CK'D BY _____ OK'D BY _____
 April 6, 2015
 RESUBMIT Yes Rejected
 By Rob Young DATE 04/13/2015

SHOP DRAWING REVIEW

VT ROUTE 114 BRIDGE #13
 RETAINING WALL PLAN
BURKE, VT

VT ROUTE 114 BRIDGE #13
 BRIDGE RAIL REINFORCING
BURKE, VT

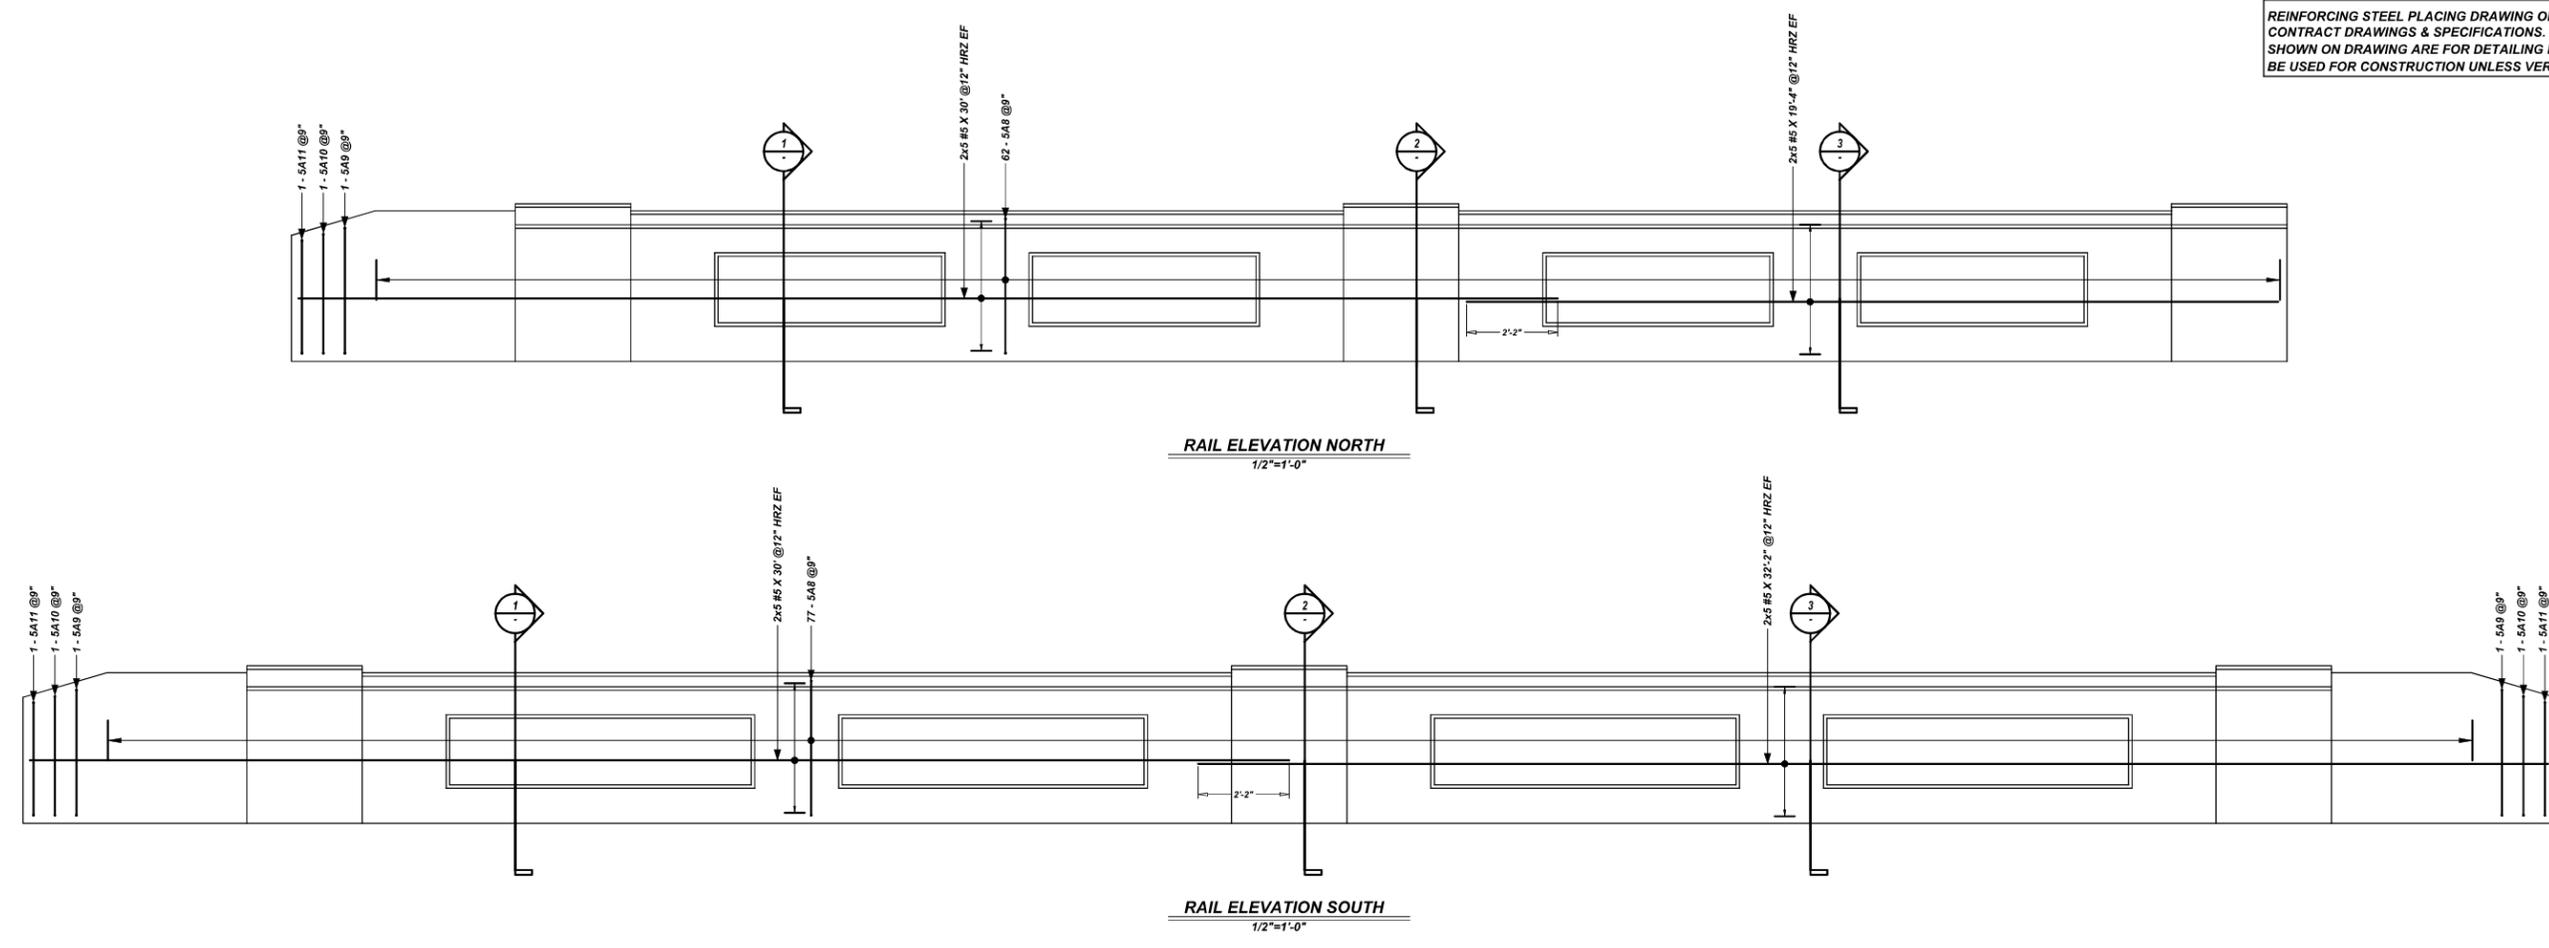
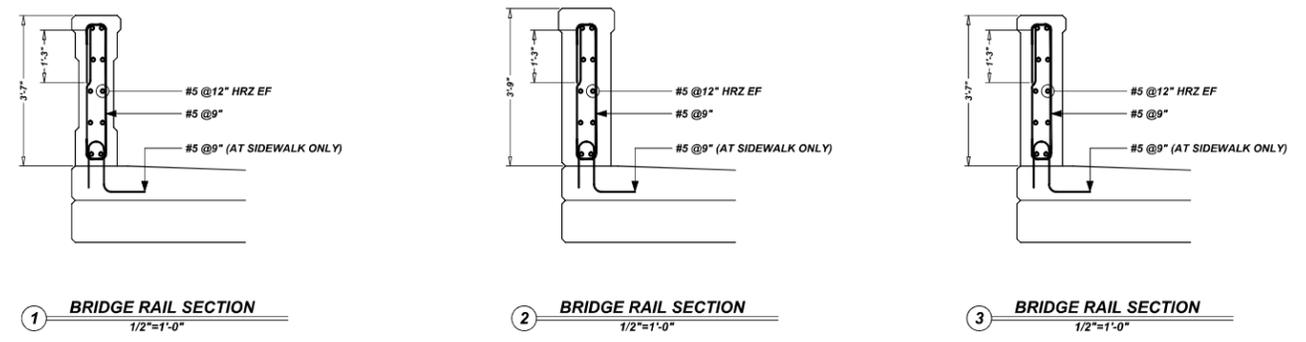
8'-9" VERIFY.
